**GOVERNOR JUAN F. LUIS HOSPITAL AND MEDICAL CENTER (GJFL)
ST. CROIX, UNITED STATES VIRGIN ISLANDS**

**PHASE 1 (T.O.R. – TEMPORARY OPERATING ROOMS)
AND PHASE 2 (DIALYSIS)
IFB025JFLHC18(C)**

CLARIFICATIONS TO BIDDERS

MARCH 28, 2018

Figure No. 1

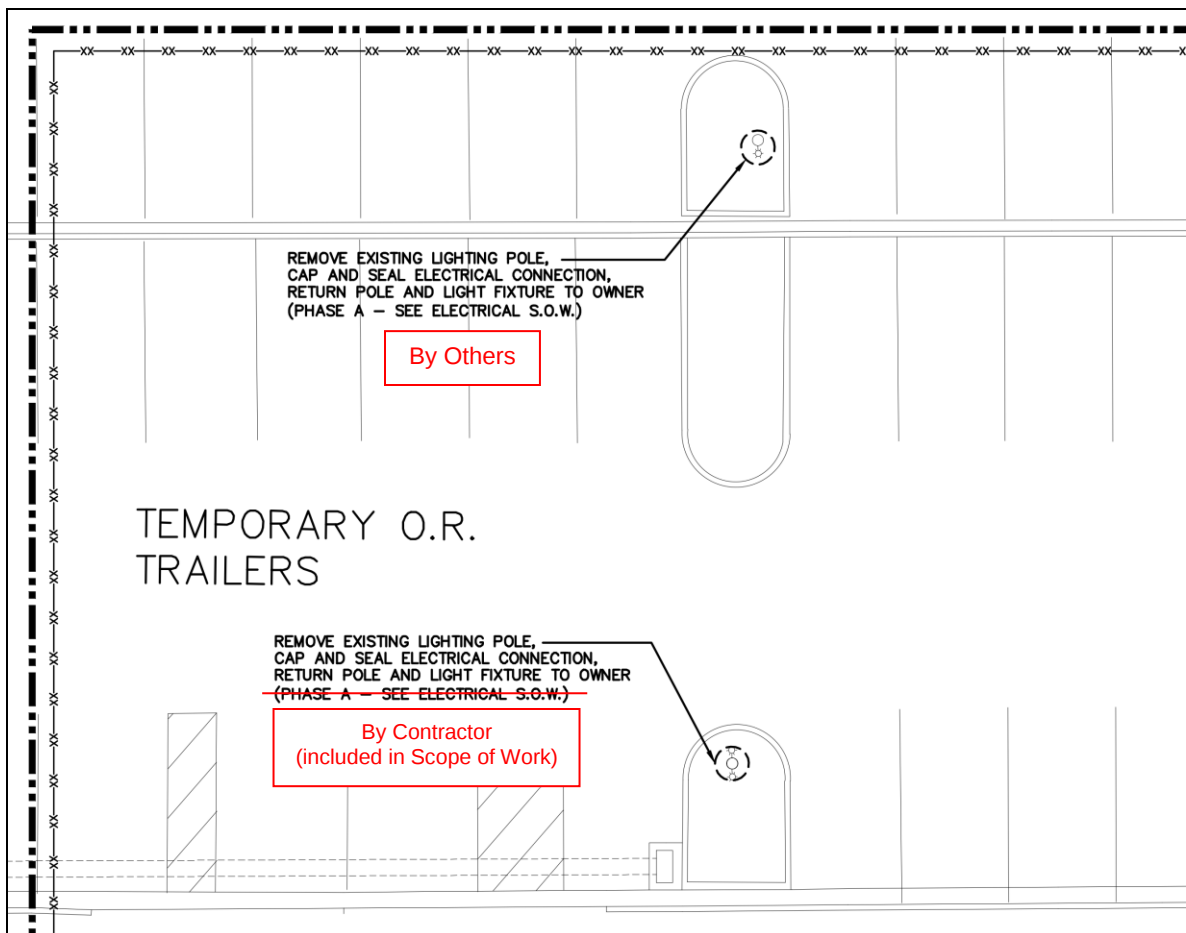
1. In Drawing No. C1-10 – Demolition Plan - Phase 1 (T.O.R.), existing lighting poles removal shall be as per **Figure No. 1**, attached.
2. In Drawing No. C2-10 – Site Plan - Phase 1 (T.O.R.), existing lighting poles removal shall be as per **Figure No. 2**, attached.
